From: Tai, Tom
Sent: Tuesday, August 07, 2012 4:26 PM
To: Chappell, Coley; Tomkins, James
Cc: STPCOL
Subject: FW: Downstream Fuel Effects Tests
Attachments: Chapter 6 Followup Presentation JUne Action Items Only- NRC.pdf

Tom-----The proposed wording on Slide 35 is different than in COLA Rev.7, App. 6C (although similar). My question is.....is the Rev.7 wording the final version?

South Texas Project Units 3 & 4 Presentation to ACRS Subcommittee Chapter 6 Follow-up

Hot Assembly Flow vs. Blockage Factor

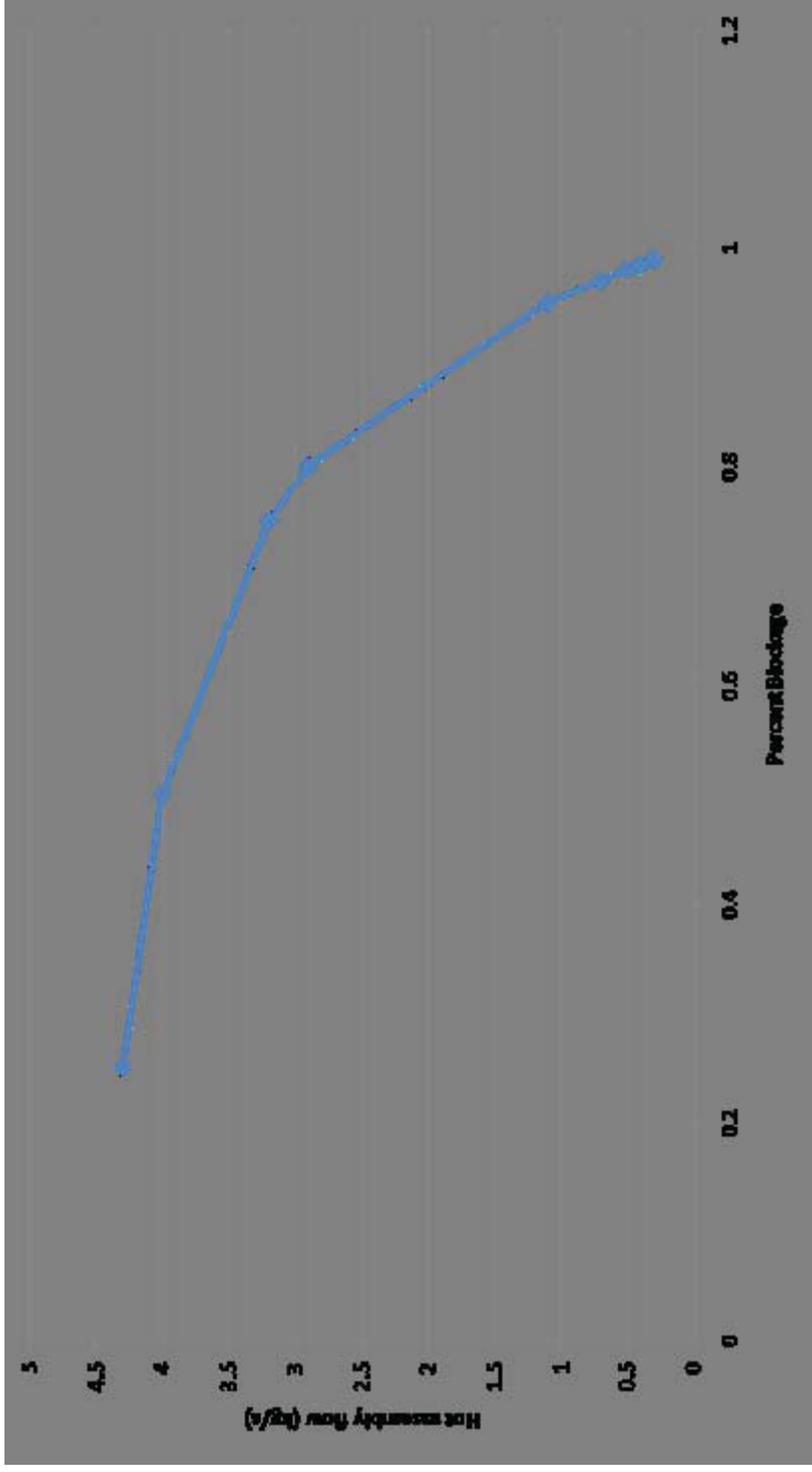
- Action Item # 84
- *ACRS requested a parametric study of k-factor vs. flow rate*
